Project: West Battery Park City Resiliency
Project – Design Services

Date: April 20, 2020

RE: Addendum #3
of Pages: 11

**West Battery Park City Resiliency Design Services Project:
Project Site Map**

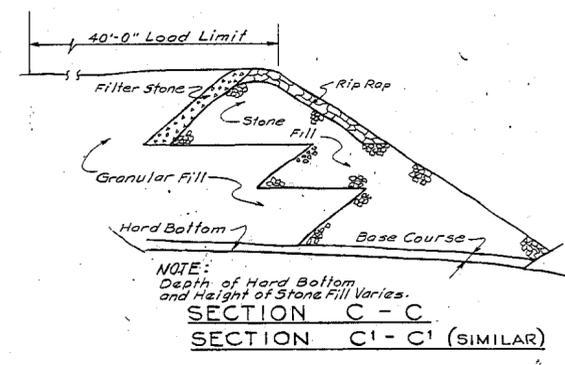
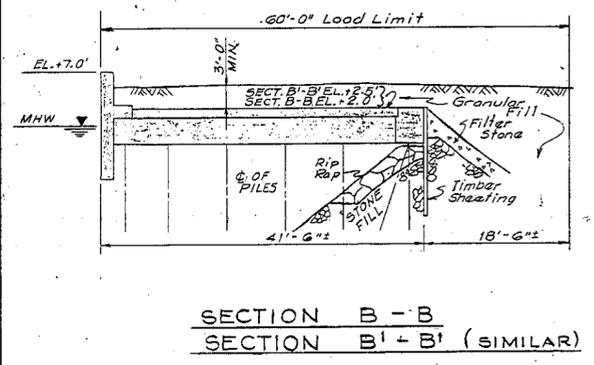
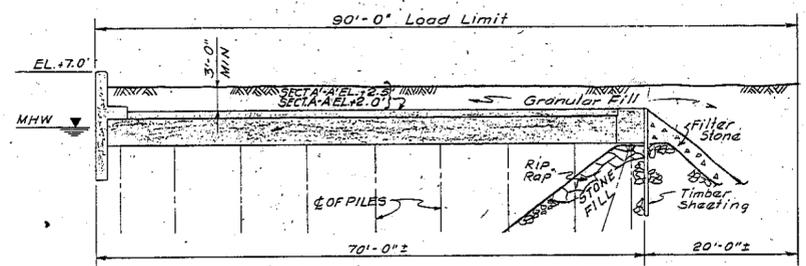
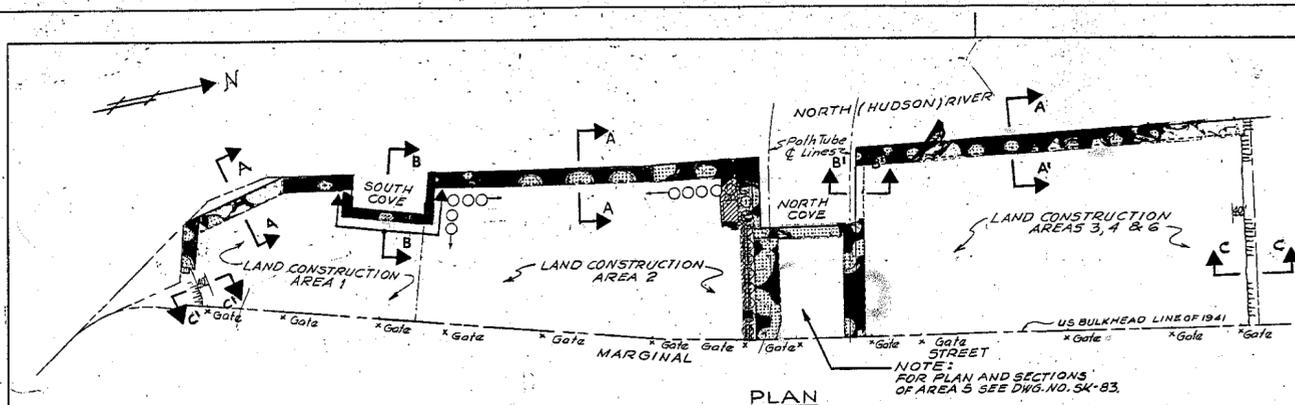
31. Can you share a drawing showing the boundaries of the relieving platform?

Response: A drawing showing relieving platform boundaries is attached to this Addendum as Exhibit A.
